**Confirmed Minutes of the 254th Meeting
of the Advisory Council on the Environment (ACE)
on 19 August 2022 at 9:30 a.m.**

Item 4 : Report and follow up discussion on the 154th Environmental Impact Assessment Subcommittee Meeting - EIA report on "Technical Study on Partial Development of Fanling Golf Course Site – Feasibility Study"
(ACE Paper 11/2022)

沼澤林地的主要水源分析 Main Water Sources of Swampy Woodland

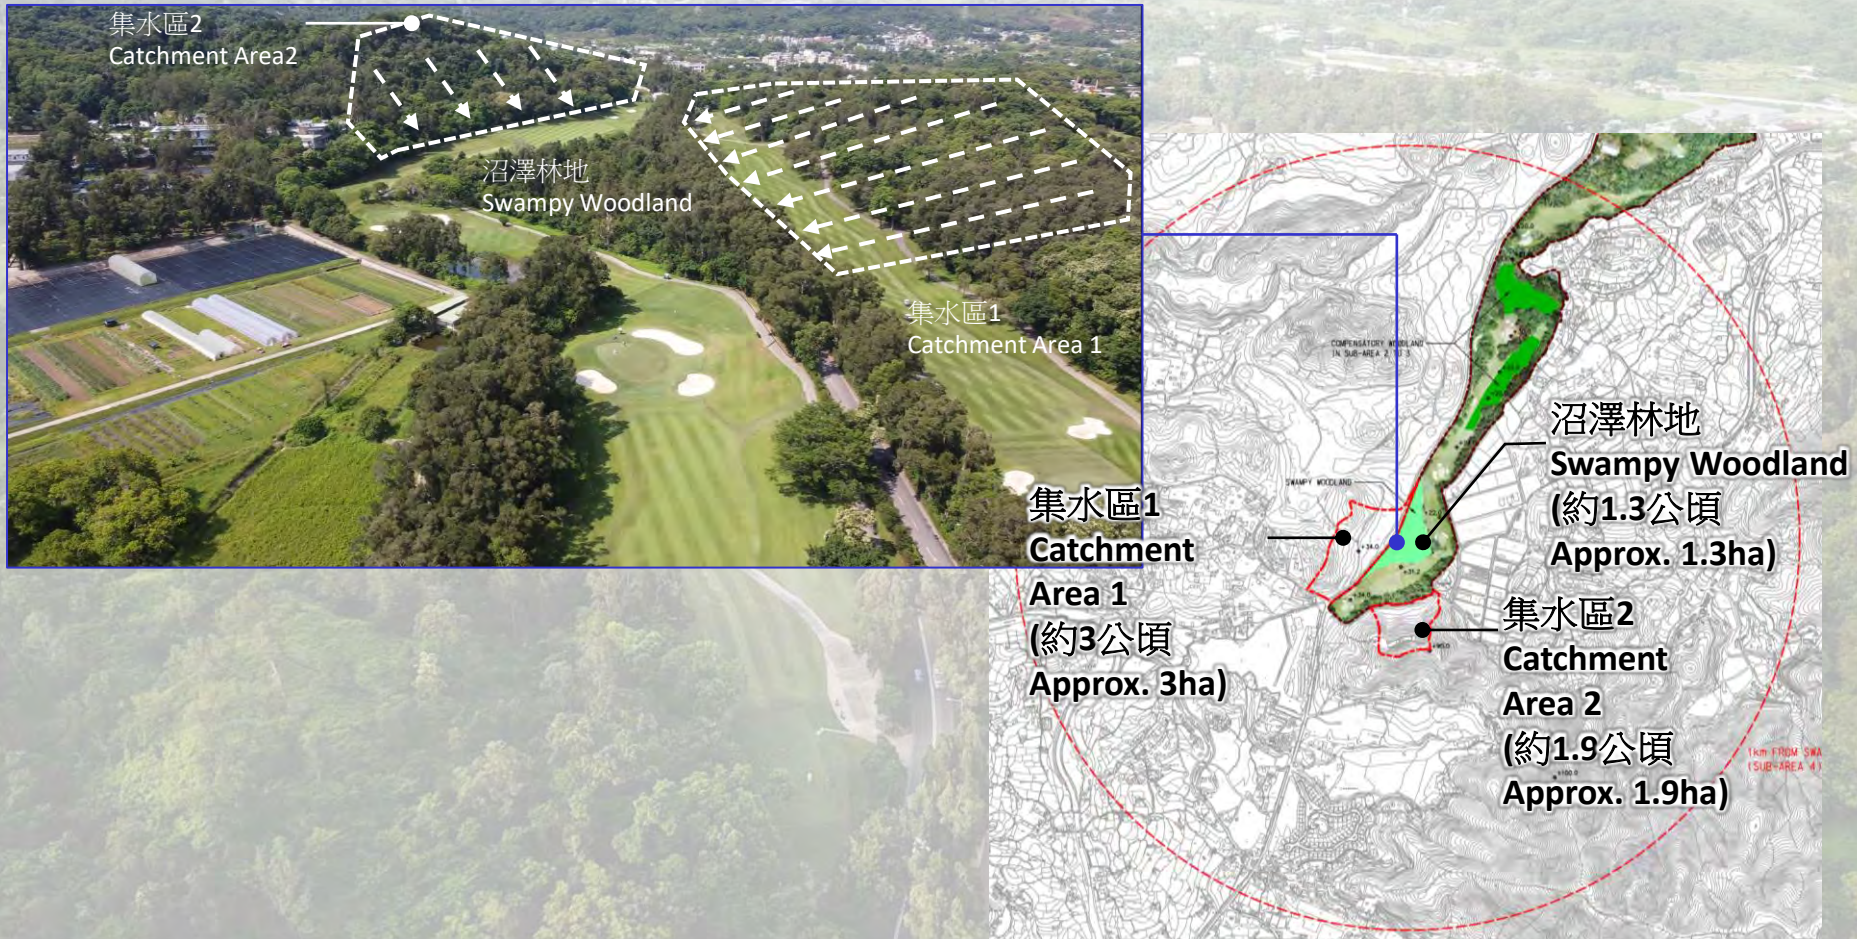
- elaborate with scientific expertise, methodology and data the hydrological impact on the Chinese Swamp Cypress and woodland habitats in sub-areas 3 and 4 with consideration of the change due to the proposed development, tree plantation as mitigation measures, and available water sources in both wet and dry seasons in these sensitive areas;
- provide hydrology impact assessment and mitigation measures to demonstrate the feasibility of the proposed layout of the housing blocks and amenity buildings (with consideration to allow reasonable substructure / foundations and impervious paving areas as well) for the 12,000 residential units;

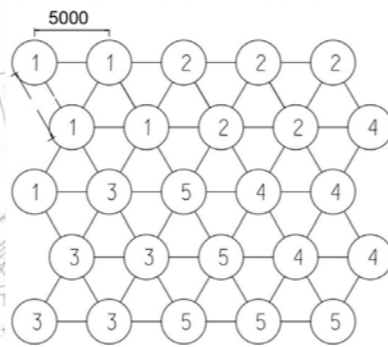
- provide detailed tree compensation plan including the numbers, species and tentative locations of compensatory tree planting to illustrate that the compensation would not result in adverse ecological impacts on sub-areas 2 to 4 while also considering plantation of native fruit trees and trees as habitats for fauna to enhance the ecosystem; and

照明眩光評估 Lighting Glare Assessment

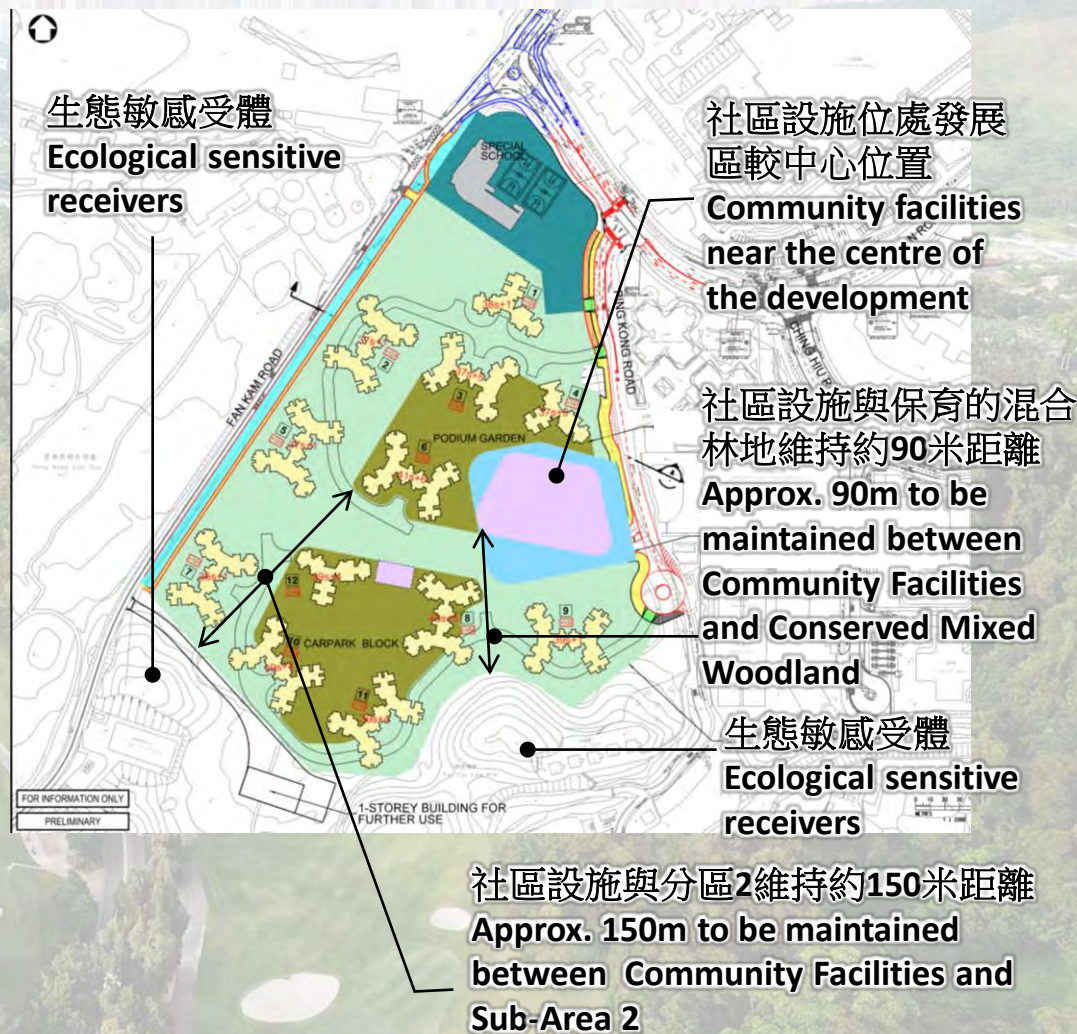
- provide detailed assessment of the lighting glare impact with the support of scientific data including the design, disposition, location and layout of the proposed housing blocks and amenity buildings, on the woodland habitat and associated fauna of the project site in both the construction and operational phases.

以一般街燈在距離地面10米作基準計算：
With a typical street lamp at 10 m from ground as the basis:

地點 Location	最短距離 (米) Nearest Distance (m)	光線強度的減少 (倍) Reduction in Light Intensity (times)
社區設施至保留的混合林地 Community Facilities to Preserved Mixed Woodland	90	1/81
社區設施至分區2 Community Facilities to Sub- Area 2	150	1/225
